Date: **December 10, 2018**

Project: **Red Rocks Community College Community Room Relocation**

## ADDENDUM # 2

**1 FLOOR FRAMING PLAN**

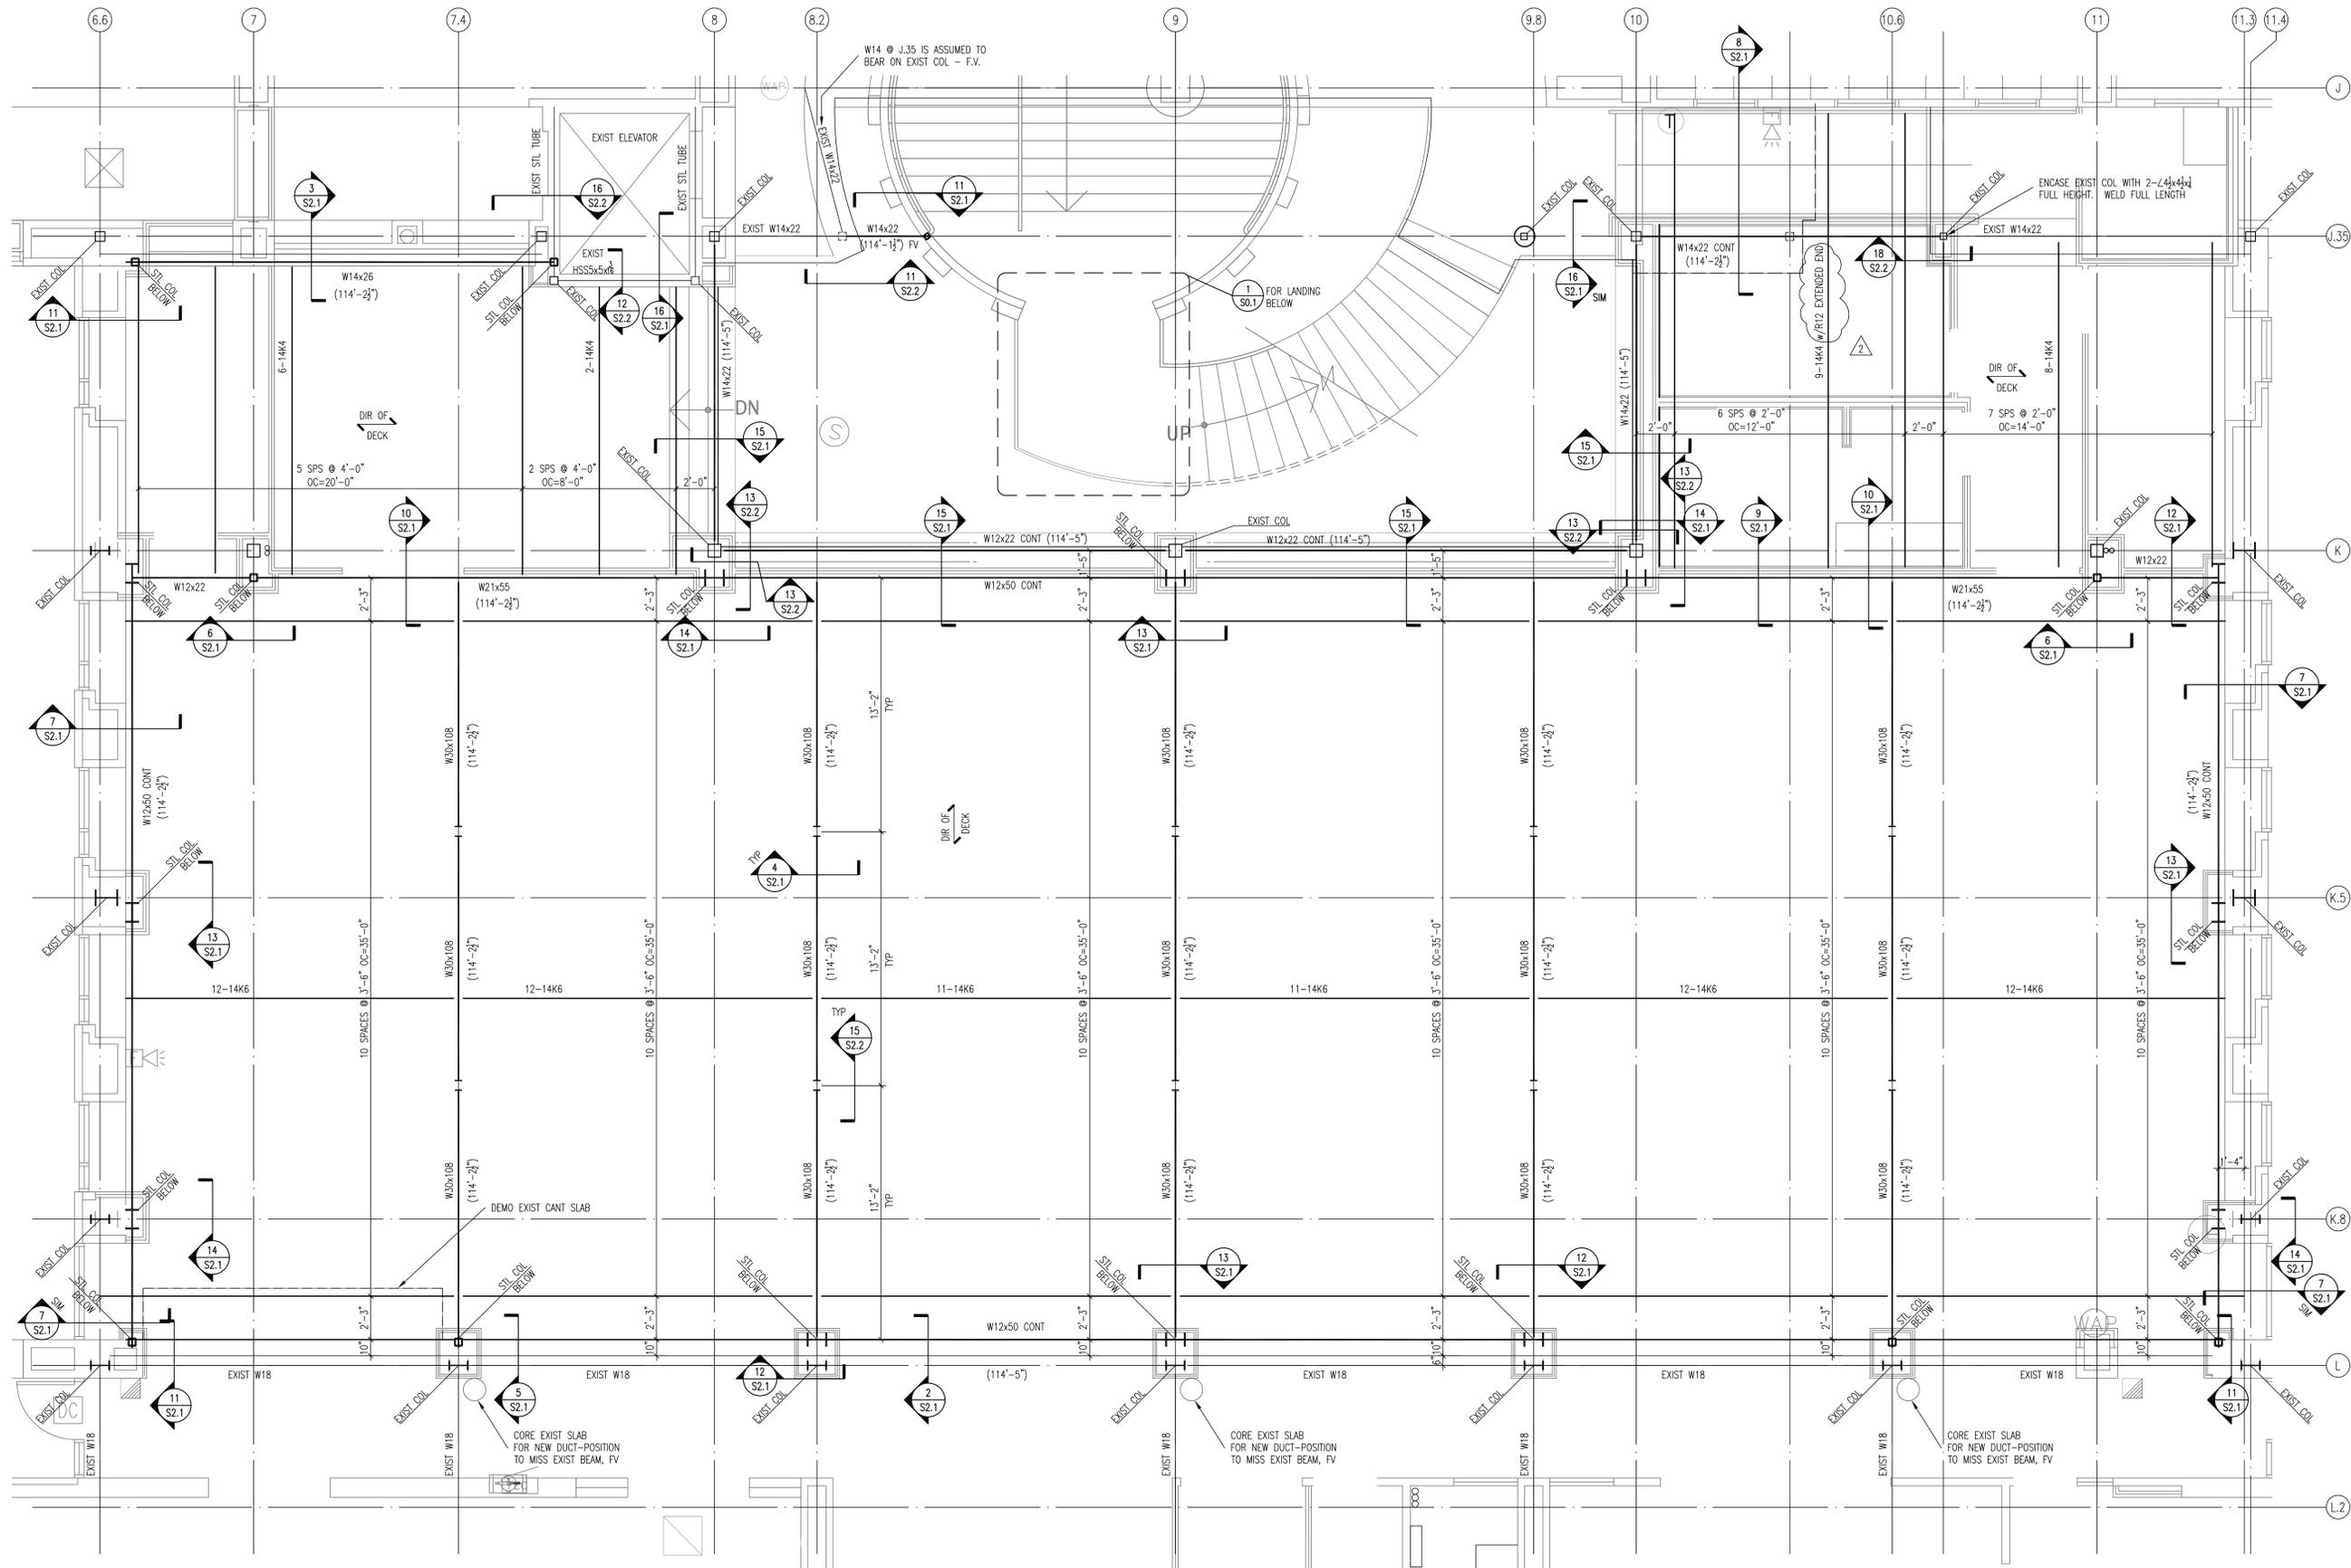
Item 6: **Drawing S1.2:** Revise joist callout.

8 SECTION  
S2.1 3/4"=1'-0"

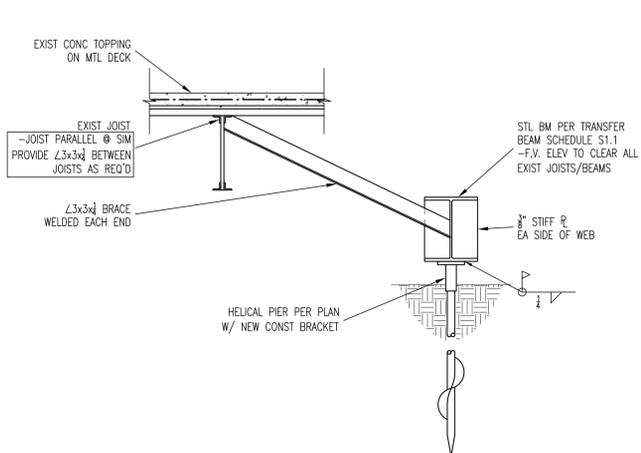
Item 7: **Drawing S2.1:** Revise detail 8/S2.1
